# Access Compliance Report

## Public Rights-of-Way

Intersection ID: 19766	Main Street: W_ARROWWOOD_RD	Cross Street: WHITEHALL_PARK_DR	Location: SW
ADA ID: 81CC7EB7359A	Ramp Type: Perp	Initial Pass/Fail: Fail	Overall Compliance: No
Severity Score: 57.5			
Codes/Mitigation Info/Possible Solution		Field Measurements/Component Compliance

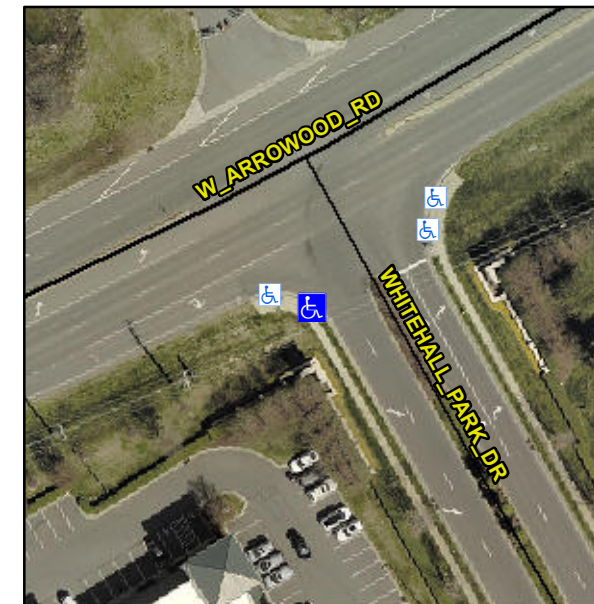
**Not Found, R304.5.1, R304.5.3, R302.7**

Compliance	Description	Data	Compliance	Description	Data
N/A	Ramp Length (in)	48.0	Yes	Ramp Slope (%)	8.0
No	Ramp Width (in)	35.0	No	Ramp XSlope (%)	7.3
N/A	Flare Type LT	N/A	N/A	Flare Type RT	N/A
N/A	Flare Slope LT (%)	N/A	N/A	Flare Slope RT (%)	N/A
N/A	Flare Traversable LT?	N/A	N/A	Flare Traversable RT?	N/A
N/A	Landing Length (in)	N/A	N/A	DWS Provided?	N/A
N/A	Landing Width (in)	N/A	N/A	DWS Contrast?	N/A
N/A	Landing Slope (%)	N/A	N/A	DWS Length (in)	N/A
N/A	Landing X Slope (%)	N/A	N/A	DWS Full Width?	N/A
N/A	Landing Curb? (Y/N)	N/A	N/A	DWS Offset (in)	N/A
N/A	Shared Landing?	N/A			
N/A	Gutter Ponding?	N/A	N/A	Gutter Slope (%)	N/A
N/A	Gutter Lip Ht (in)	N/A	N/A	Gutter X Slope (%)	N/A
N/A	Painted X Walk1?	No	N/A	Painted X Walk2?	N/A
	X Walk 1 Direction	To E		X Walk 2 Direction	N/A
N/A	X Walk 1 Width (in)	N/A	N/A	X Walk 2 Width (in)	N/A
	X Walk 1 Slope (%)	4.4		X Walk 2 Slope (%)	N/A
	X Walk 1 X Slope (%)	6.0		X Walk 2 X Slope (%)	N/A

N/A	Ramp inside XWalk1?	N/A	N/A	Ramp inside XWalk2?	N/A
	Road Slope (%)	N/A	N/A	Clear Space?	N/A
	Road X Slope (%)	N/A	N/A	Clear Space to XWalk (in)	N/A
N/A	Any Obstructions?	N/A	N/A	Storm Grate/Utility Hazard?	N/A
	Obstruction Type			Storm Grate/Utility Type	
		N/A			N/A
		No		Surface Condition? (G/P)	Poor

**Remove & Replace Entire Ramp.**
